MODEL: iR2200/ 2800 / 3300

SUBJECT: Frame Breakage of Paper Pick-up Units

Failure of Spring Support

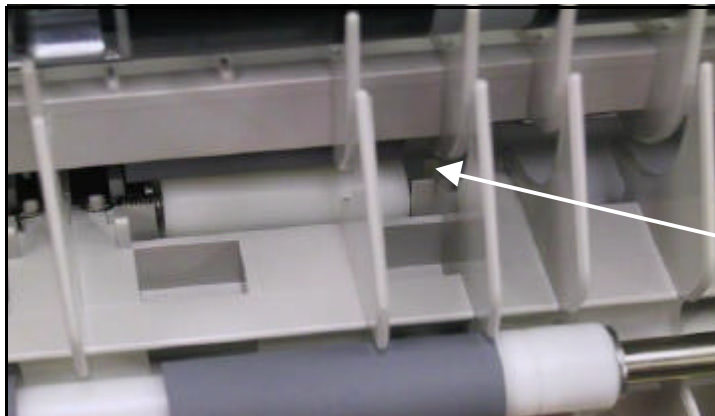
There have been reports of a small number of frame breakages to the Paper Pick-Up Units, (FG6-5644-000), on the iR2200/2800/3300 products.

Symptoms are skew feed from the upper cassette. This is caused by a breakage to the white plastic frame, supporting a spring that runs through one of the paper feed rollers (FB3-2848-000).

Photo of modified paper pick-up

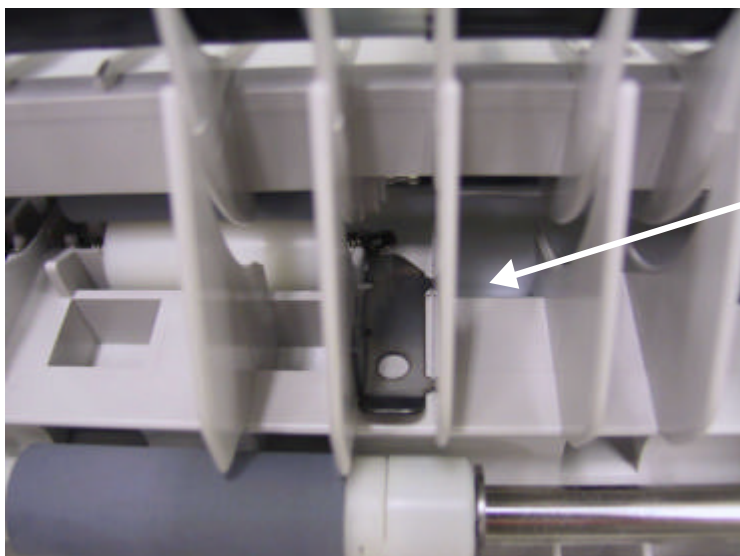
(Rear white roller with FA9-3948-000 shown)

The front roller and rear roller require different modification parts (*see photo below*). These are fairly straightforward and are simply pushed into place.

The modified bracket is a tight fit.
